**TOWN OF BAY HARBOR ISLANDS
MORRIS N. BROAD COMMUNITY CENTER
1175 95TH STREET
BAY HARBOR ISLANDS, FL 33154**

DEVELOPMENT & REVIEW COMMITTEE MEETING

**TOWN OF BAY HARBOR ISLANDS
COMMUNITY DEVELOPMENT
MEMORANDUM**

Subject: Site Development Plan Application
1085 Townhouses – 6 DU Townhouse Complex
1085 94th Street
Bay Harbor Islands Acct. No. SPR24-000025
MMPA Account No. 01-0702-1197

BOUNDARY SURVEY

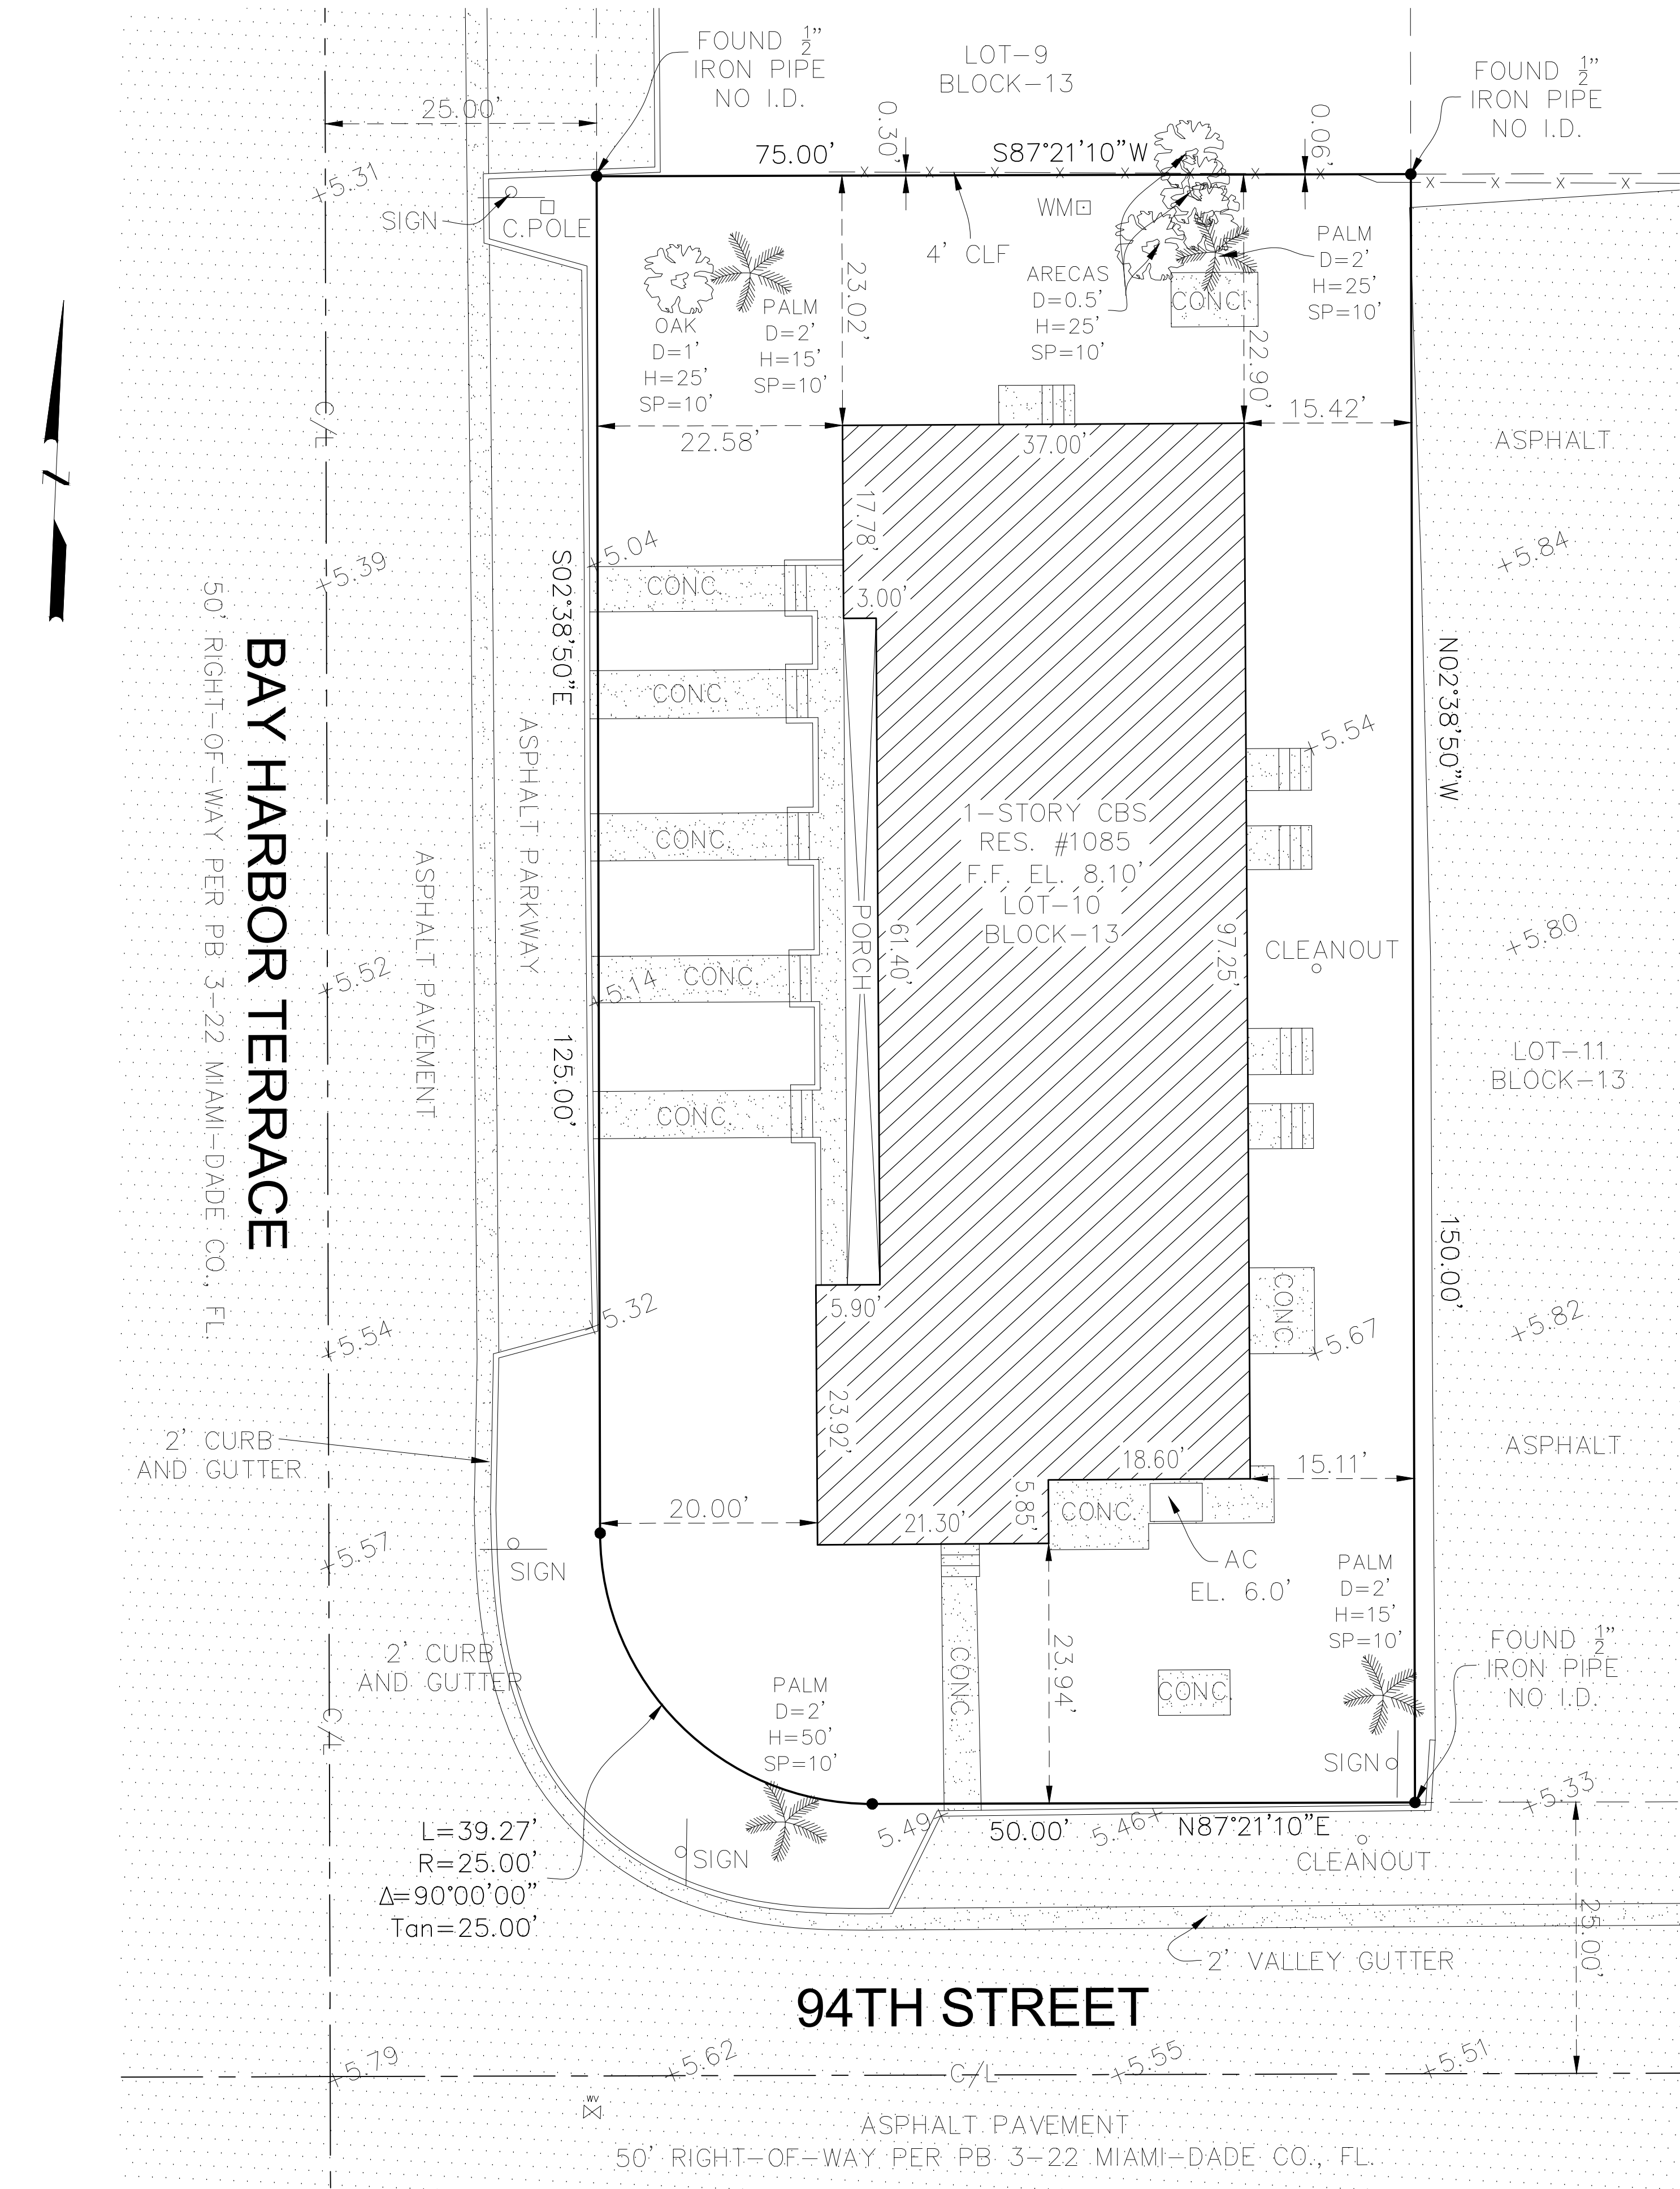
The survey does not provide the lot area or acreage as required. The Miami-Dade County Property Appraiser website lists the lot area as 11,250 square feet; however, this is not correct, as the corner lot is missing the area in the arc radius. The survey should be updated to provide a calculated square footage and acreage. The site plan lists the lot square footage as 11,116 square feet / 0.26 acres – how was that determined? Based on the site plan square footage of 11,116 square / 0.26 acres, a maximum of nine (9) dwelling units could be built at the maximum allowable base density (34 DUA). The proposed project proposes six (6) dwelling units. The Town's records do not identify and TDR sales from this site; therefore, it appears the site will have three (3) TDR units.

- 1) As noted above, the survey submitted does not include a calculated lot square footage / acreage – which is smaller than a regular rectangular platted lot due to the loss of area at the corner. Revise the survey.

SITE PLAN,
SITE DATA &
LOCATION PLAN

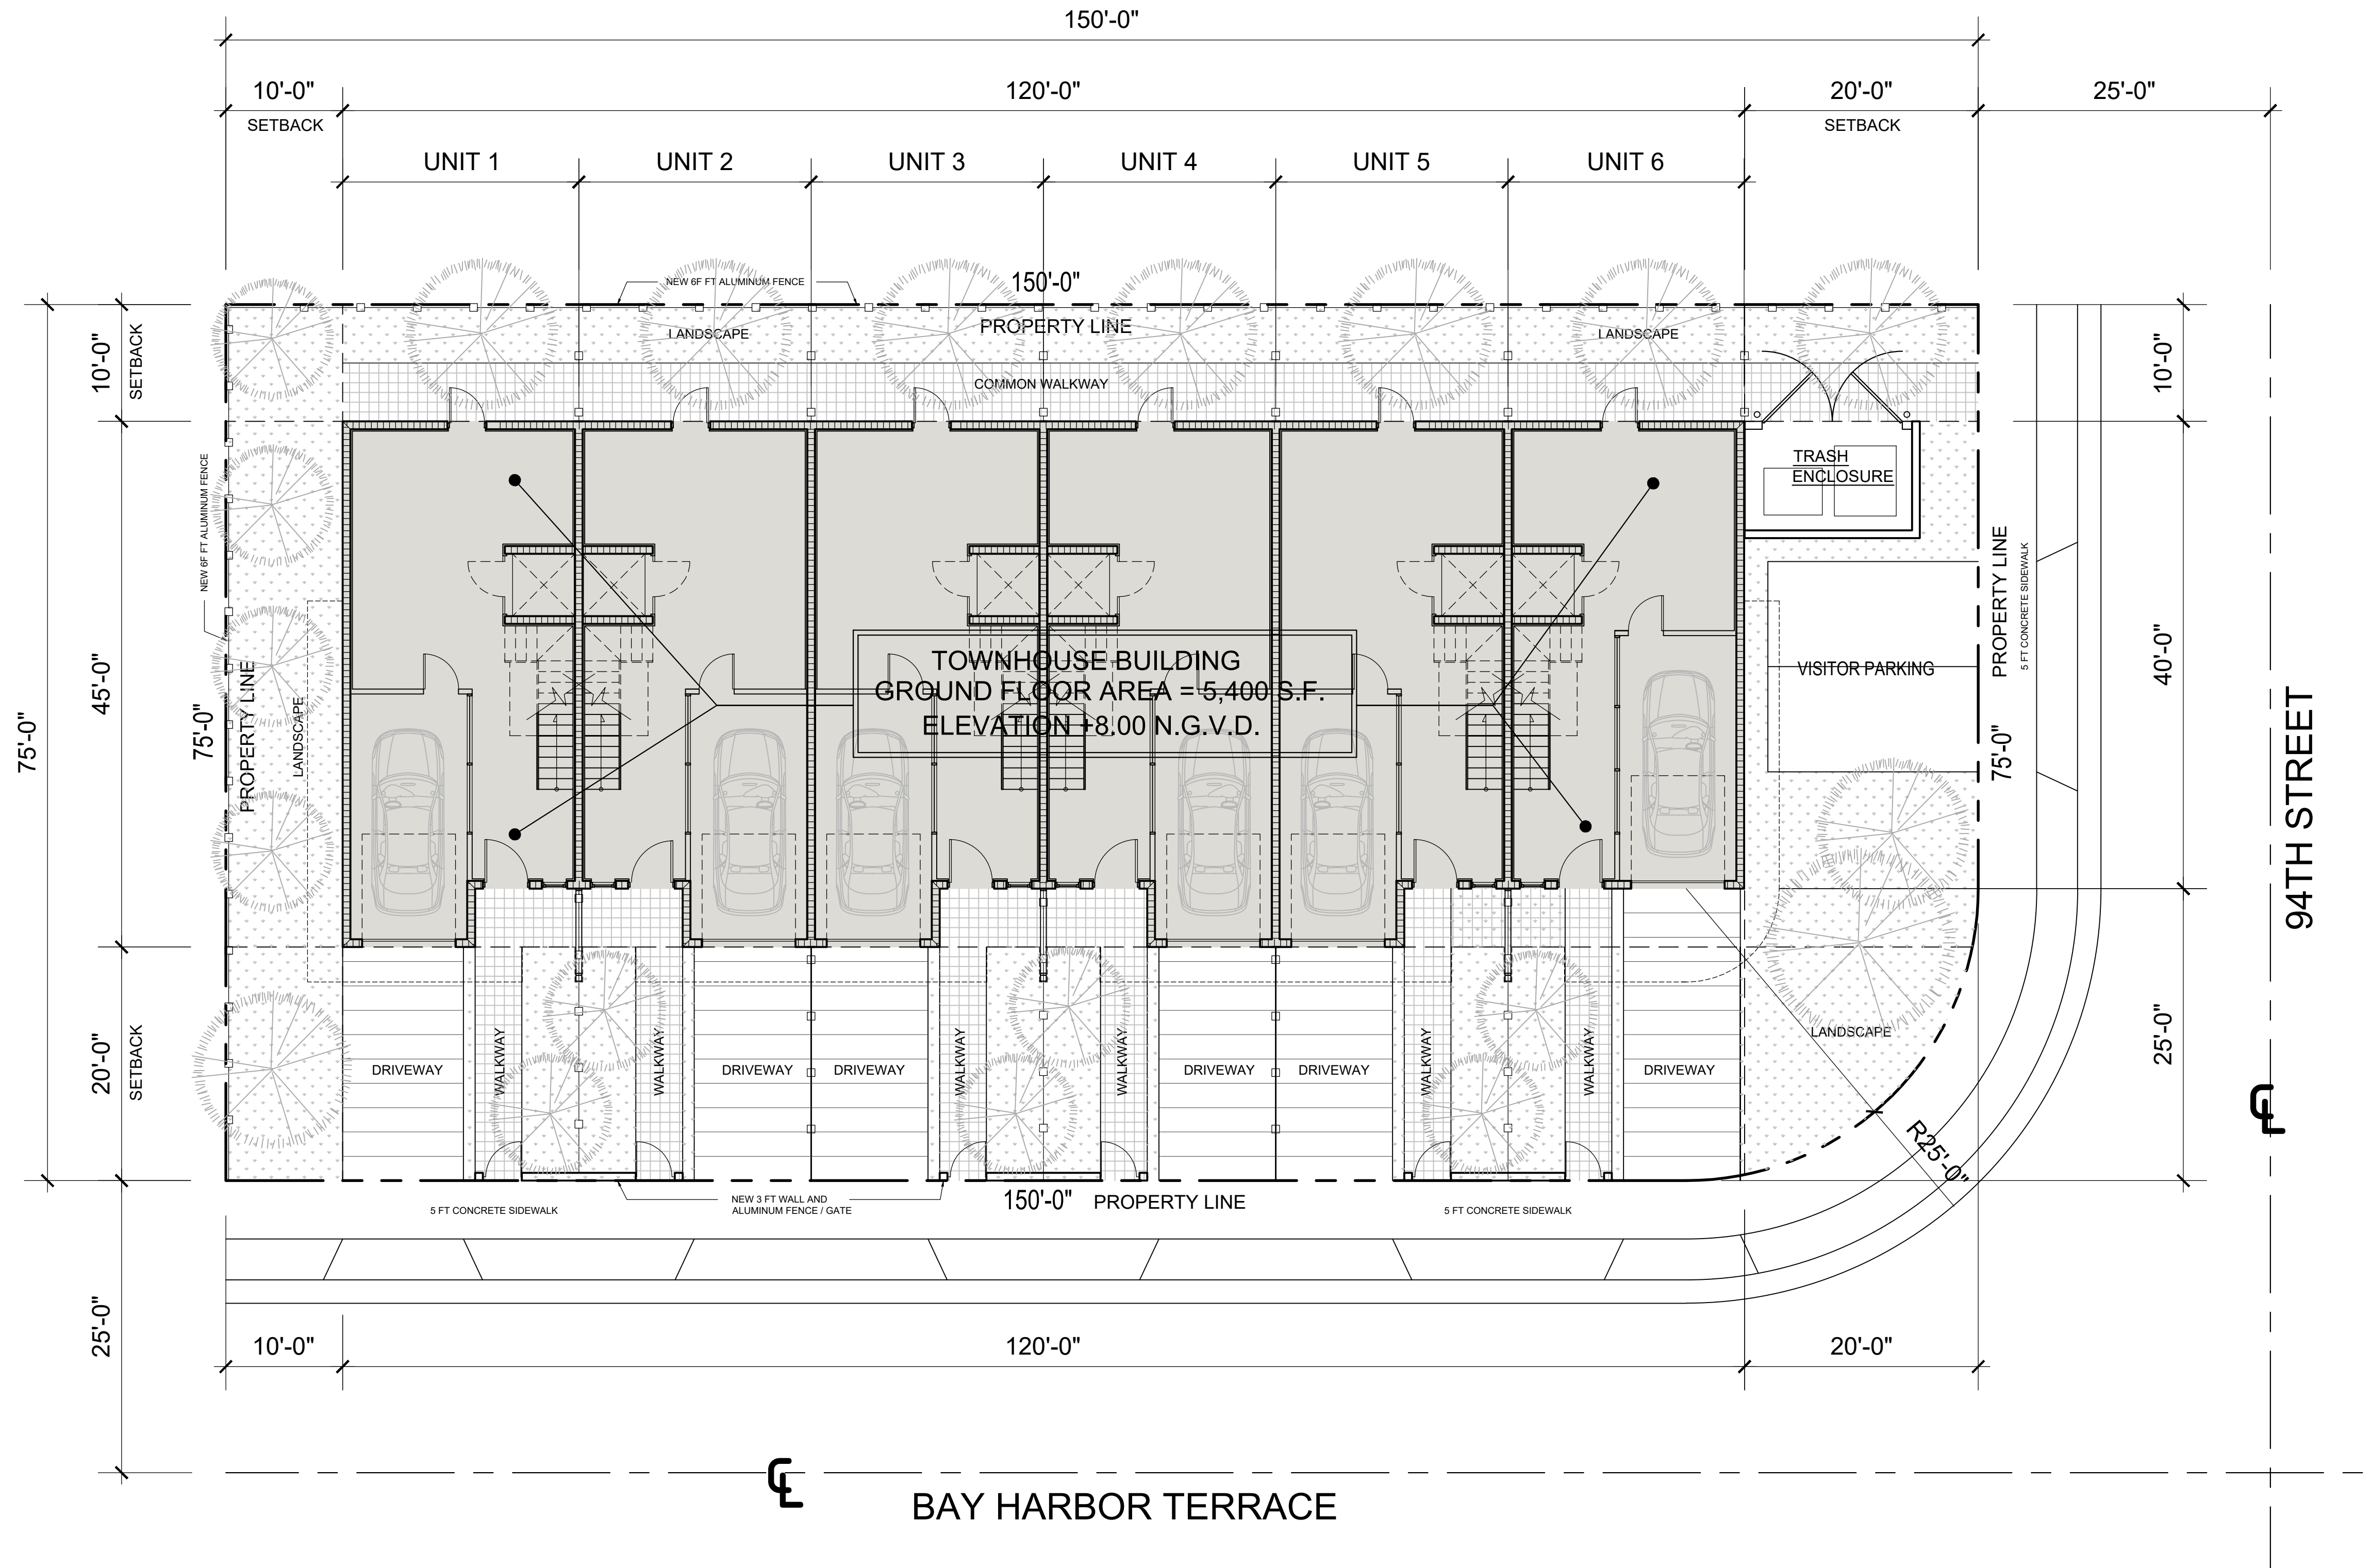
The required front setback for 94th Street and Bay Harbor Terrace for portions of buildings less than 30 feet in height is 20 feet. For portions of buildings between 30 feet and 45 feet in height is 25' - not 20' as shown. Base side setbacks are 10 feet. Side setback above 30' in height increase one (1) foot for each three (3) in height above 30'. The top floor building height is 40'. The side setback should be 13' not 10. The minimum rear setback is 10 feet but increases above 30' in height by one (1) foot for each three (3) in height above 30 feet. The setback should be 13'.

- d. Provide dimensions for the parking spaces. The min. size is 8'-6" x 18'.
 - e. As per the above the driveway to the garages may not serve as the 2nd parking space. Provide a 2nd parking space for each DU as required.

- f. As per the above each driveway must be separated by a min. 2' landscape strip.
 - g. Dimension the width of the common walkway at the rear of the building and a dimension from the walkway to the property line. The min. setback in 5'.

- h. Dimension the width & length of driveways.
 - i. Dimension the width of all front walkways. The maximum width is 5'.
 - j. Provide a north arrow.
 - k. Provide drawing scale. Could not determine the scale of the plan.

- l. The proposed wall & fence along the west property line (BHT) must be setback a min. of 2 feet from the street property line (to allow for landscaping) and they must not be more than 3-feet solid above grade. Provide a wall / fence detail showing the material. See Sec. 23-12(22).

- m. The elevation of the garage is shown at 6 feet. Per Sec. 5-17 of the Town Code, enclosed garages must be at least 18" above grade. Garage elevations must be at least 7'-2" +/- in elevation. Update the General Code Data table accordingly.

SECOND FLOOR PLAN

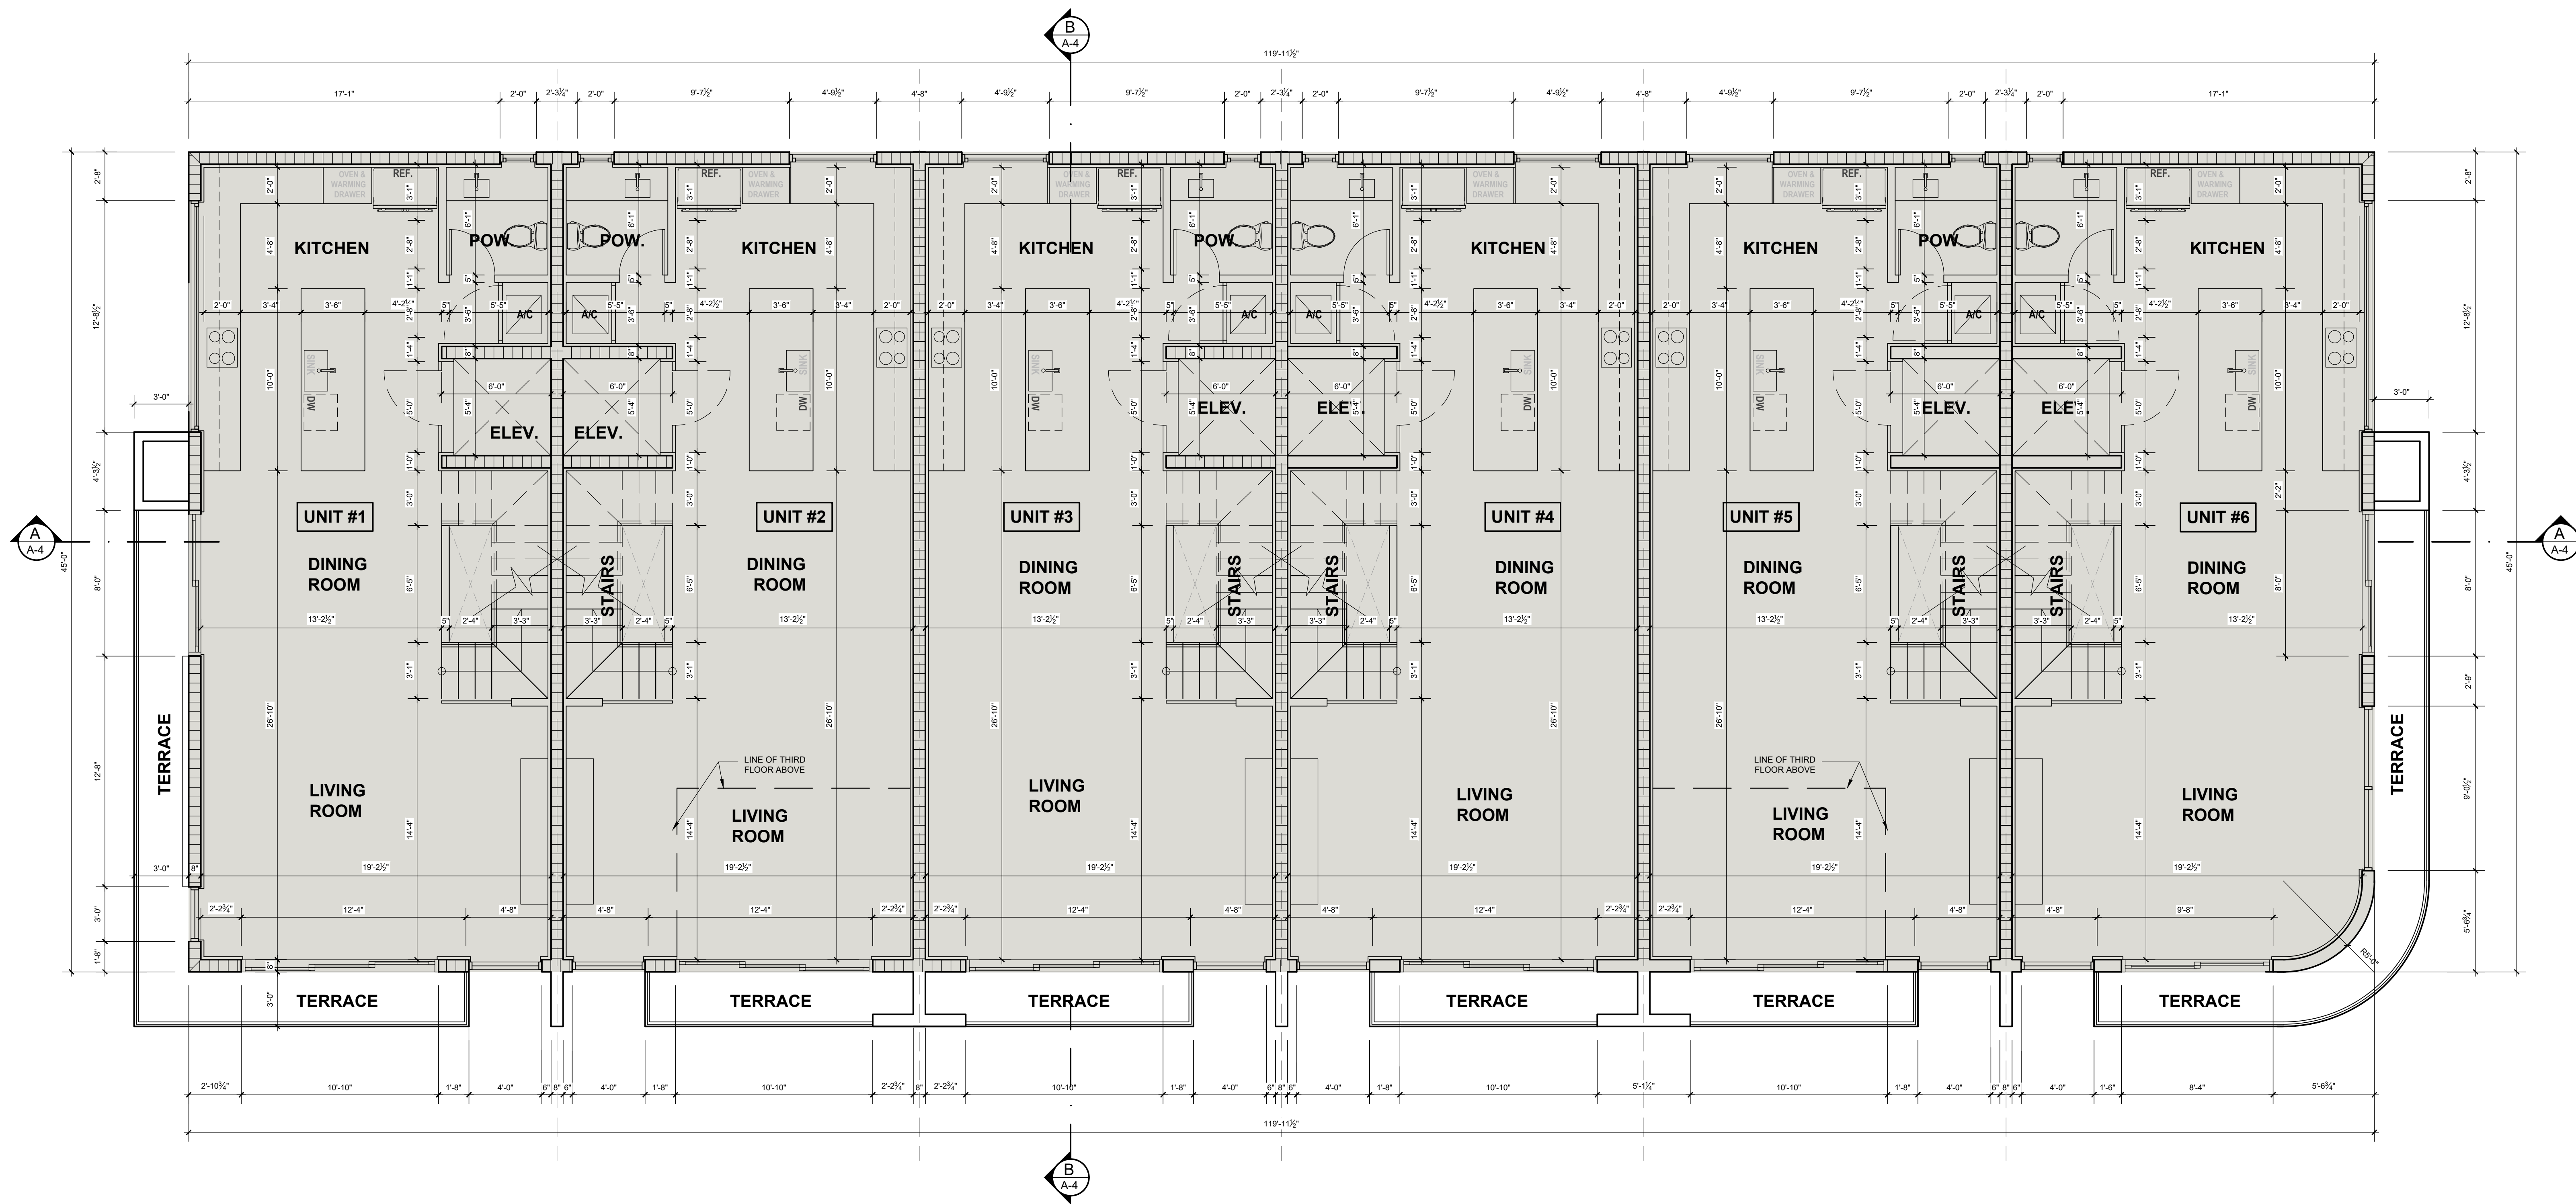
- 12) On Sheet A-2A there are box shaped structures on the north / south building facades at the end of the “terraces / balconies”. What are these – setbacks apply.
